SB 3-873-001

SUBJECT: CERTAIN WX TRUCKS WHERE THE TECH PANEL SPACER WAS OMITTED DURING INSTALLATION

Service Bulletin Information

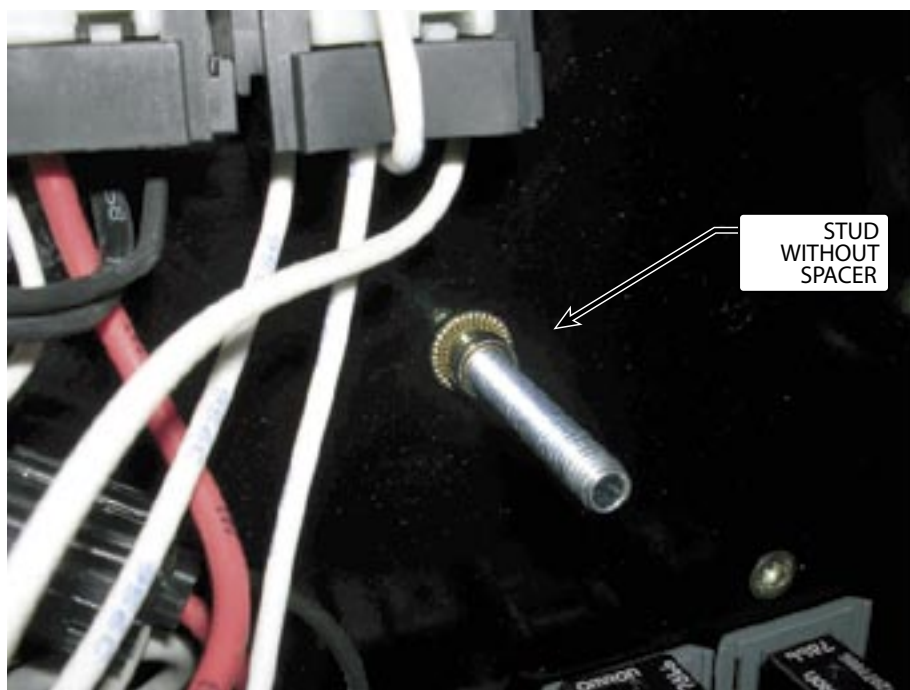
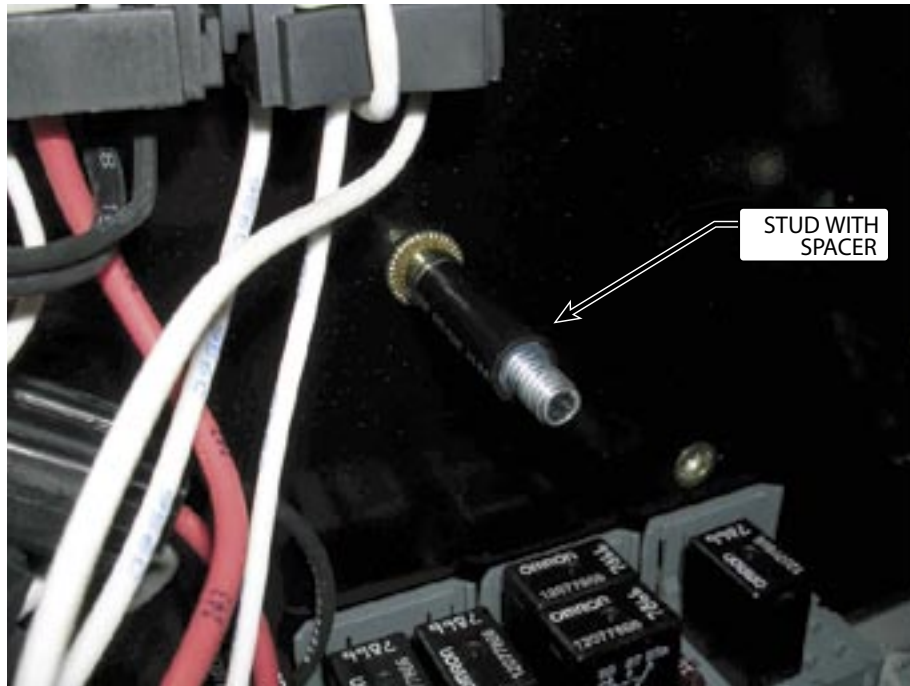
There should be a spacer installed over the threads of the wing nut stud, 1.25" long and made from a length of 3/8" nylon air brake tubing.

If this spacer has been omitted and the wing nut is over-tightened, the panel cover will contact the transmission control relays and could cause them to internally short circuit. Refer to included photos for more detail.

1. Park the vehicle on a level surface. Turn off the engine, apply the parking brakes, and chock the rear tires to keep the vehicle from moving.
2. Locate the Tech Panel. It is in the left-hand side of the cab, left of the steering column, under the dashboard.
3. Inspect the threaded stud where the spacer installed. If the spacer is not installed, remove the panel and inspect the relays for signs of deterioration.
4. If any relays are damaged, these should be replaced before installing the spacer and re-installing the Tech Panel cover.
5. Cut a section of plastic brake tube as described and install over the threads of the stud to which the wing nut is threaded.
6. Reinstall the Tech Panel cover and secure all three fasteners.
